FIELD SERVICE BULLETIN

FSB Number: LVCCFSB2004-6
Author: Tony Bryan
Date: January 20th, 2004
Total No. of Pages: 4
Subject: **GSM Triplets – Integrated Camera Module**
Model Affected: V300, V400, V500, V525
Level of Repair: 3

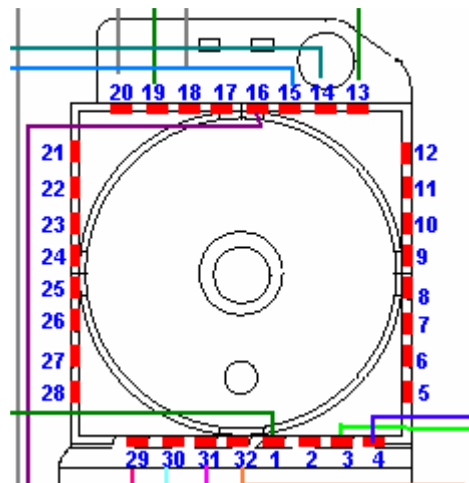
The root cause of the defect is stress to the solder joints of the imager, at both the bend and alignments sides, during the assembly of the camera module into the flip. Pins 13, 14, and 15 are the most susceptible to opens. See images below.

PHILLIPS 8489420N02 FLEX

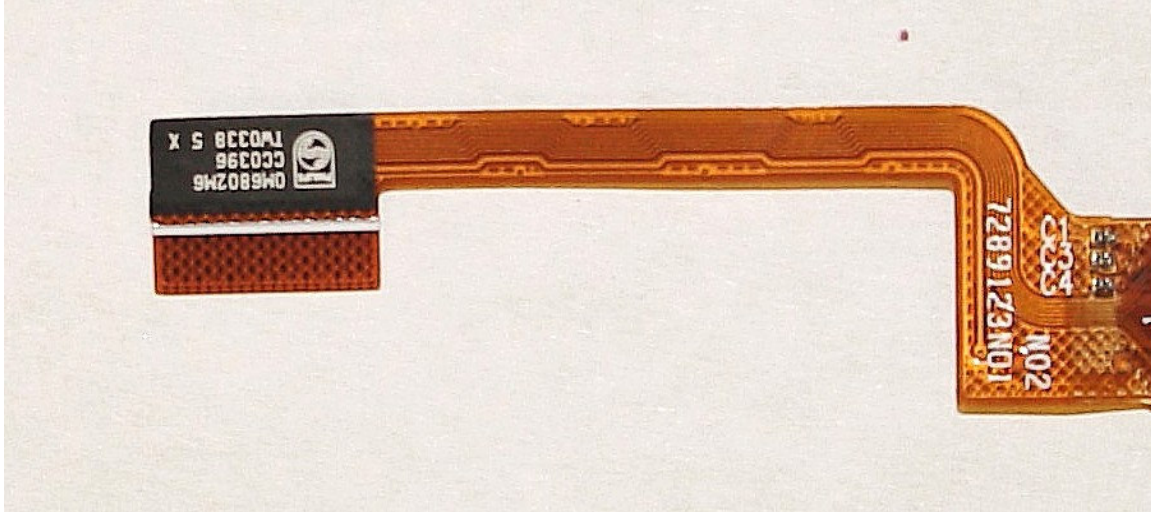
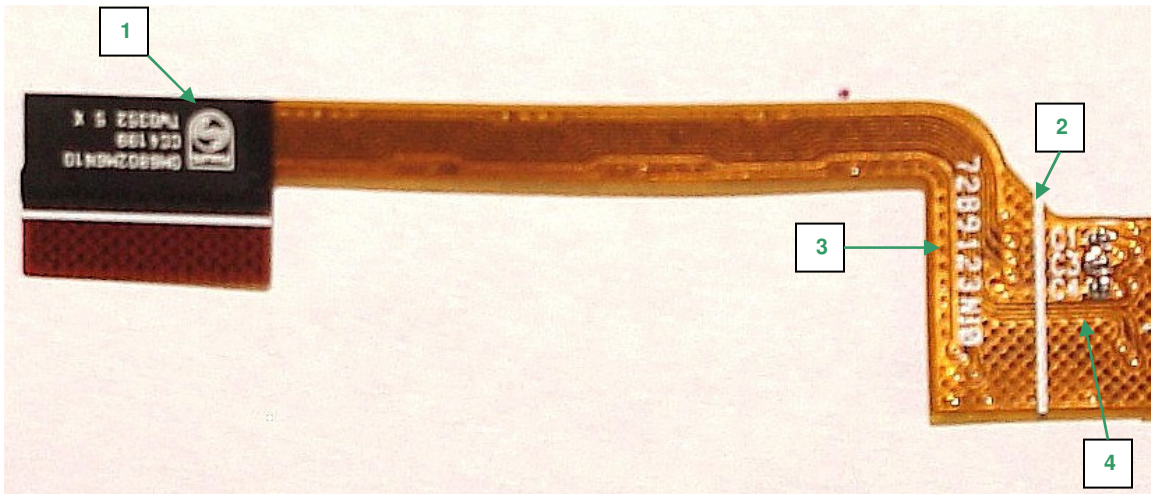
1. Phillips has changed the design of the flex from the original 8489420N02 Part to a new 8489420N03 Part with some of the surface layer traces re-routed to the bottom layer to increase the overall flexibility of the flex and reduce the amount of stress applied to the solder connections during the assembly process.
2. UV Glue will be added, by the factory, to the alignment side of the imager on all remaining Phillips Cameras built with the original N02 Flex. The UV Glue will add additional support to the affected solder connections.
3. Phillips will optimize the plating and hot bar processes to improve the overall robustness of their design.
4. Steps will be taken to optimize the assembly process of the Camera Module in the Flip Assembly to limit stress put on the imager's solder connections.

Noted Identification Markings:

1. Phillips Marking at connector
2. White line above imager part number and below components.
3. Part number printed on the flex will read 7289123N10 or 8489420N03
4. Smaller number of traces visible on surface layer

1. Perform testing to confirm the customer’s complaint is related to the issue described above.
 - a. If the unit is not related to this issue, then proceed with normal troubleshooting techniques as per the customer complaint.
2. Disassemble the unit and flip assembly to replace the camera module, with a Phillips camera built with the improved 8489420N03 flex. See Images Above.

Quarantine all existing stock of 7289123N01, N02, N06, and N07 Phillips Camera Modules. Affected modules should be sorted, using the images shown above, to identify modules built with the original Phillips 8489420N02 Flex. All modules confirmed to have been built with the Phillips 8489420N02 Flex should be removed from inventory.
